**Subject: Beaver Valley Power Station, Unit No. 1 and No. 2  
BV-1 Docket No. 50-334, License No. DPR-66  
BV-2 Docket No. 50-412, License No. NPF-73  
ISI (Inservice Inspection) Program  
Response to RAI and Revised Relief Request**

Attachment 1  
**Response to Request for Additional Information on  
BV-1 Relief request 1-TYP-3-B5.70-1, Rev. 1 submitted on February 6, 2001**

#### RELIEF REQUEST NO. 1-TYP-3-B5.70-1, Rev. 2

Figure 1

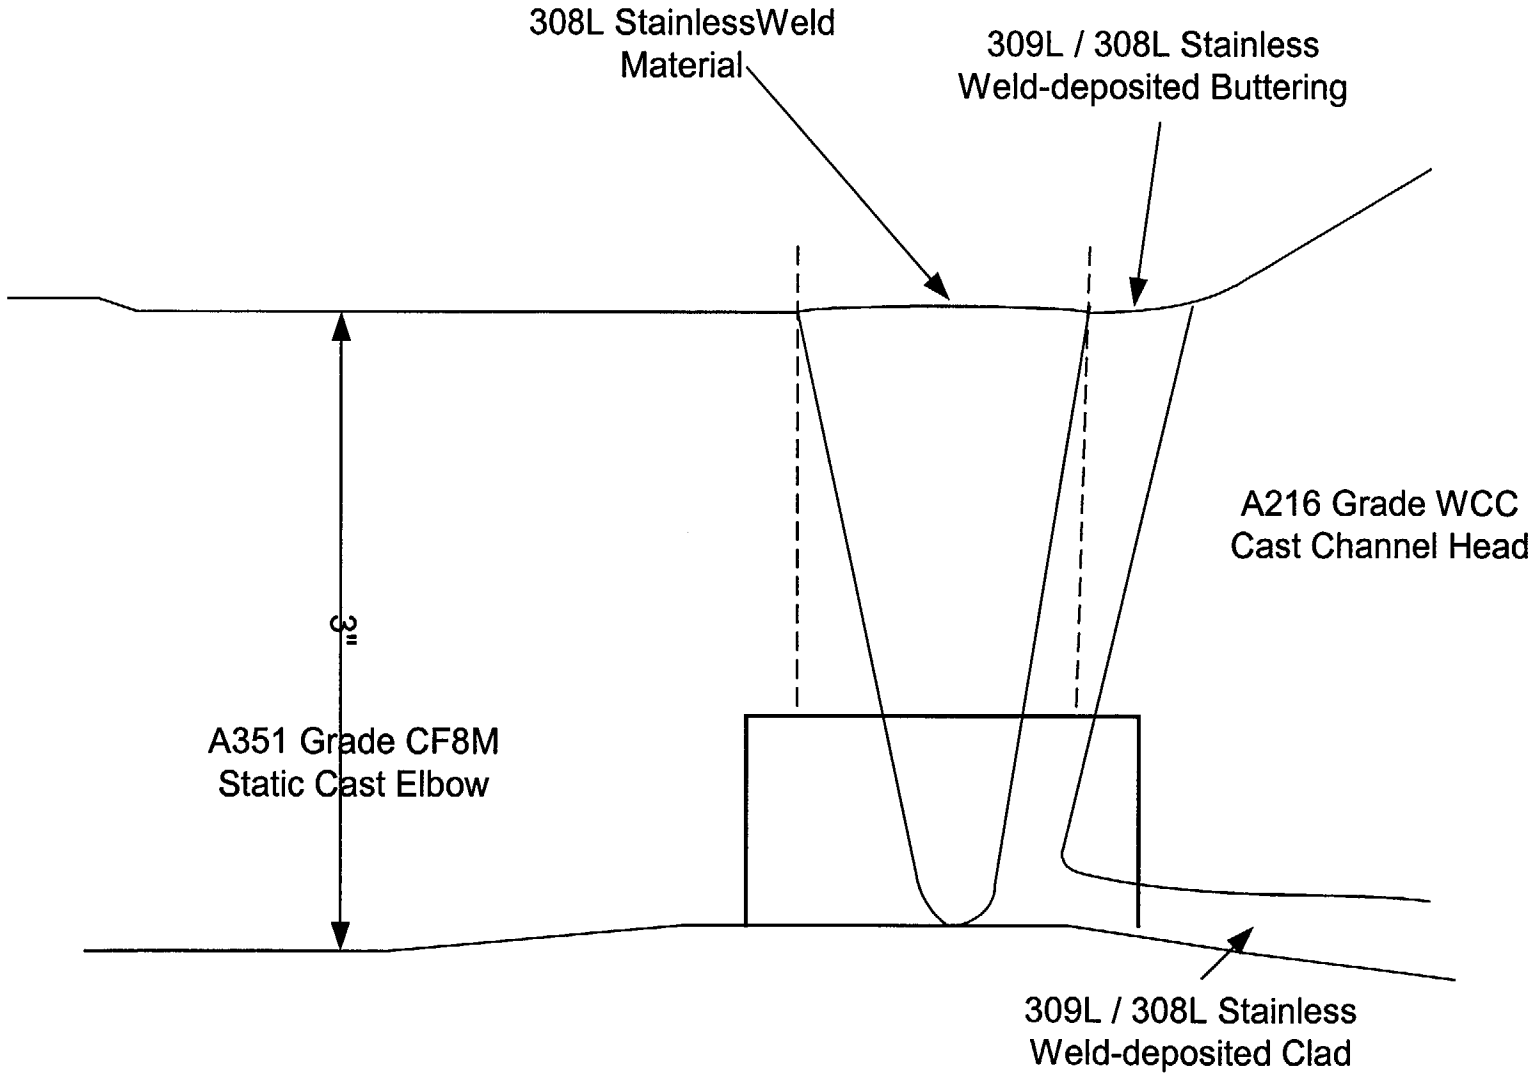
What is the weld configuration? (include base materials and weld in the diagrams)

The weld configuration and materials shown in Figure 1 are derived from fabrication drawings and ultrasonic profiling. The welds are 308L filler material joining A351 Grade CF8M cast stainless steel elbows to A216 Grade WCC steam generator channel heads. The channel heads are clad with 309L/308L stainless steel and the weld – deposited safe-ends are made with 309L/308L stainless steel material.

Figure 2

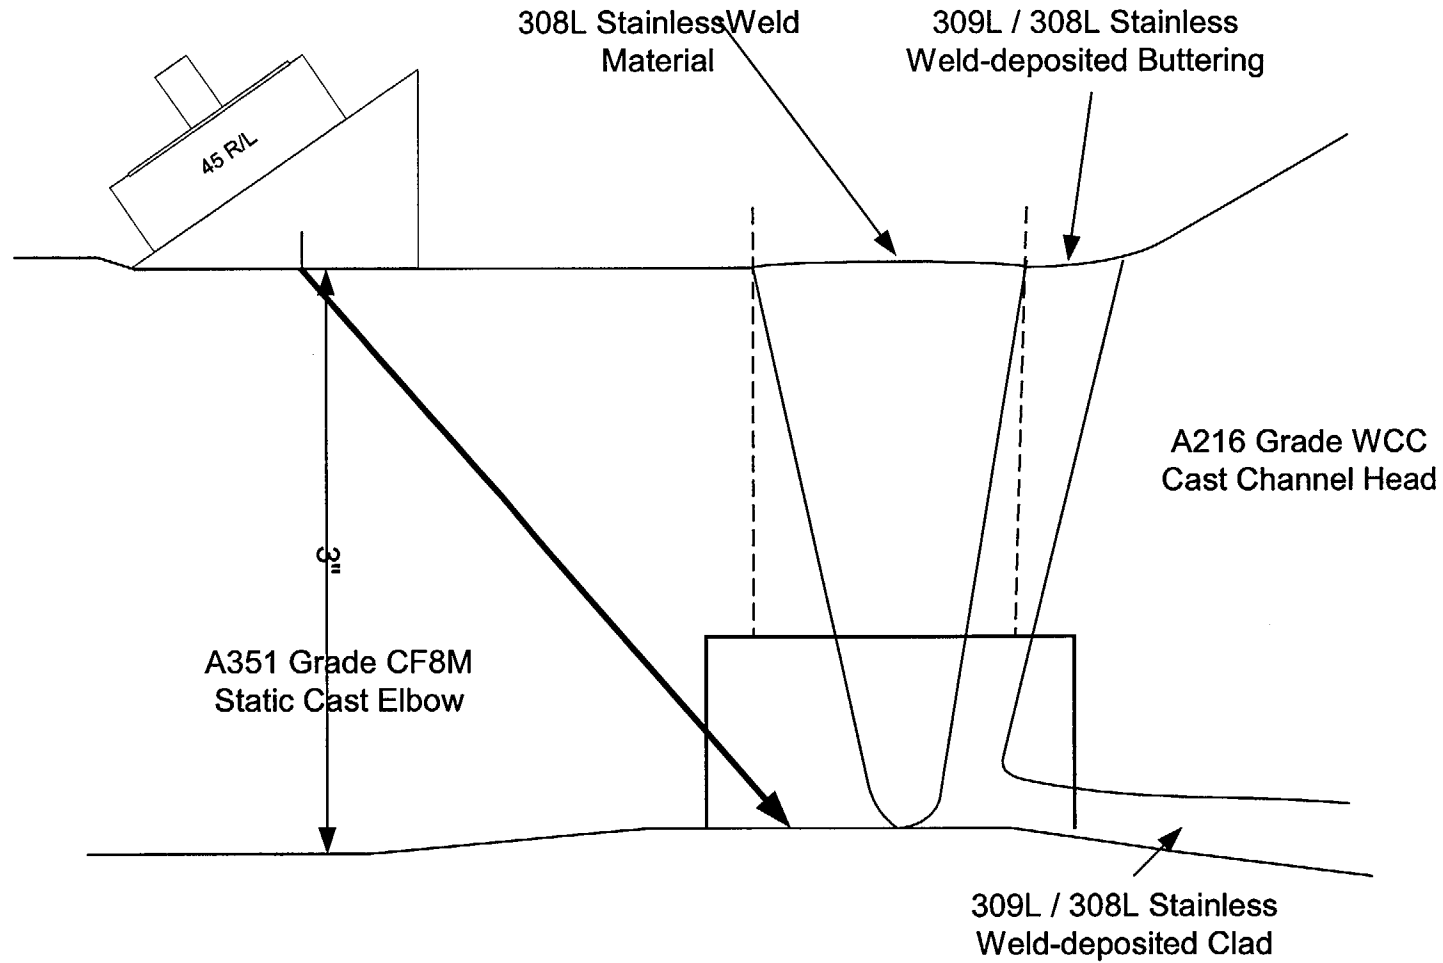
What is the reason for the examination coverage change? Please provide the reasoning and documentation for the current credited examination coverage being lower than previous examinations. The submittal stated that the limitations are documented in the most recent examination reports. Please provide documentation on the limitations and explain the current methods used to calculate coverage. Discuss and compare the changes in limitations and coverage calculations from previous intervals.

Graphical representations of the examination areas covered are provided in Figures 2 and 3 for axial scans and Figures 4 and 5 for circumferential scans. The principal coverage limitation for these welds is in the axial scan direction 2 scan (no coverage in scan direction 2 from the channel head side due to head curvature). This limitation has always been identified during examinations. Both changes in calculated coverage were the result of search unit contact limitations identified in the circumferential scans (directions 3 & 4) performed in 1997. Previous examinations did not identify limitations for the circumferential scanning directions. The limiting condition documented in 1997 is the proximity of the channel head curvature, which limits the ability of the relatively large contoured dual element search unit to make contact on the channel head side(s) of the weld(s). This causes search unit "lift-off". (See figure 6). The same search unit design has been used to examine these welds since 1984, so the loss of contact documented on the examination report was based on the experience of the examiner(s) performing the examinations.

the required examination volume. The newly identified circumferential scan limitation is based on limited coverage of the inside diameter (ID) surface on the nozzle side of the weld (Illustrated in Figure 2). Shallow, inside diameter axially oriented flaws on the nozzle side of the required volume may not be detected, however the probability of detection of such hypothetical flaws would increase significantly if they grew to significant through-wall dimension, because through-wall growth would also result in a corresponding increase in flaw length. Surface examinations (liquid penetrant) are also performed on these welds at the same frequency as the volumetric UT examination.

Figure 1

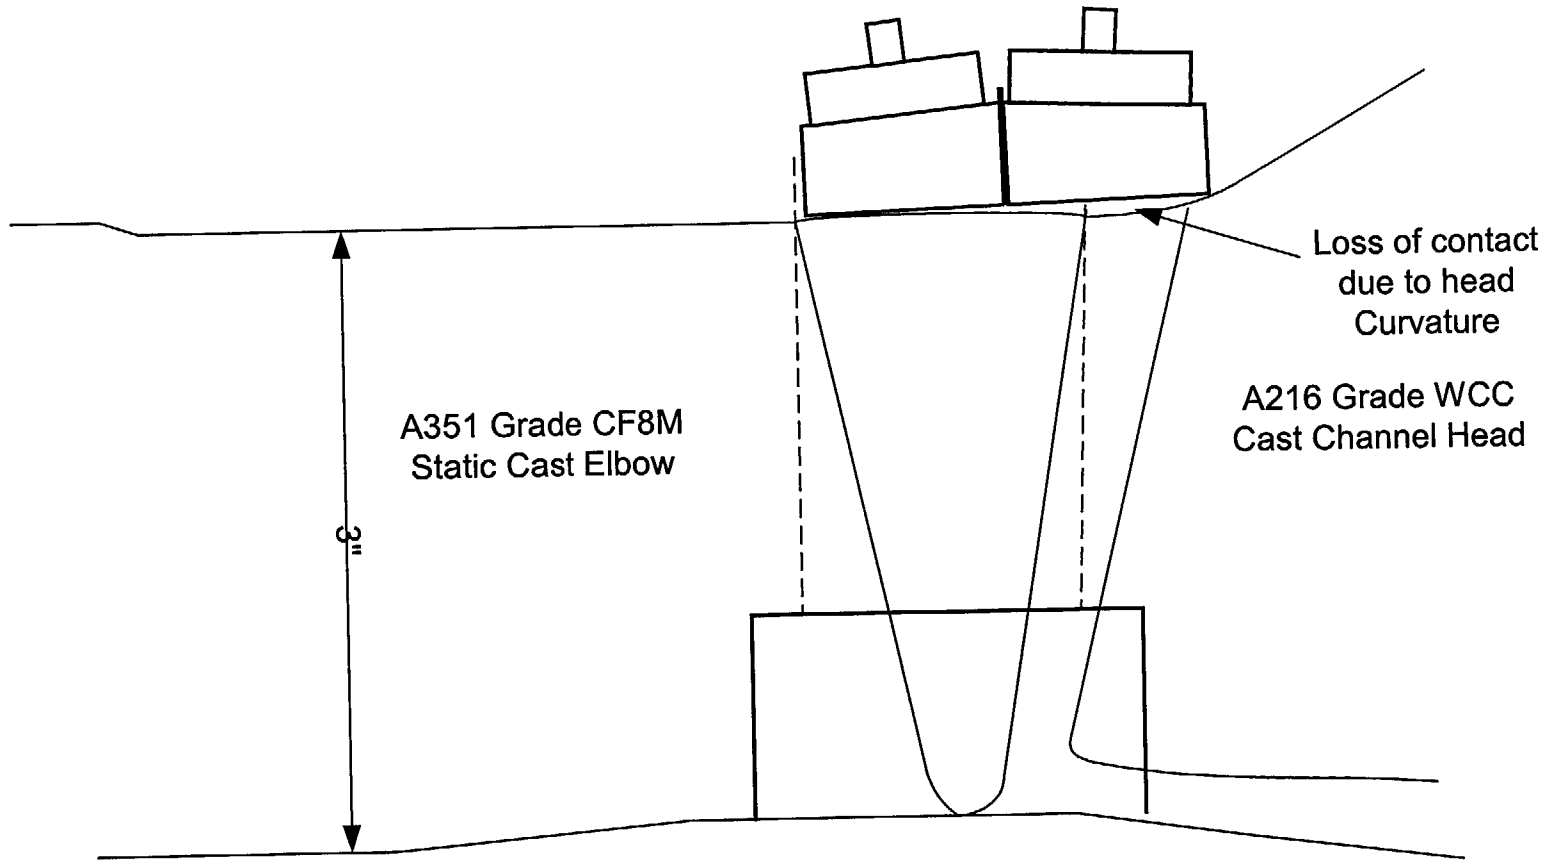
Previous examinations identified a limitation in axial scan direction 1 due to the distance from the weld to the edge of the machined surface on the elbow. This reported limitation may have been conservatively calculated. Subsequent examinations and plots on the profiled weld area have shown that this distance is adequate to attain coverage of the required volume in axial scan direction 1. Ultrasonic examinations performed during the current (3rd) Inspection Interval on the two welds resulted in complete coverage in axial scan direction 1, no coverage in axial scan direction 2 and a newly identified limitation that resulted in 55% coverage in both circumferential scan directions 3 and 4. This results in a total coverage of approximately 52% of the required volume. This limitation is illustrated in Figure 1.

The alternative to the examination requirement will be to use the completed surface examination and the completed ultrasonic examination that were performed to the maximum extent possible. The percentage of the required examination volume that was limited was recorded on the examination report and in the outage summary report.
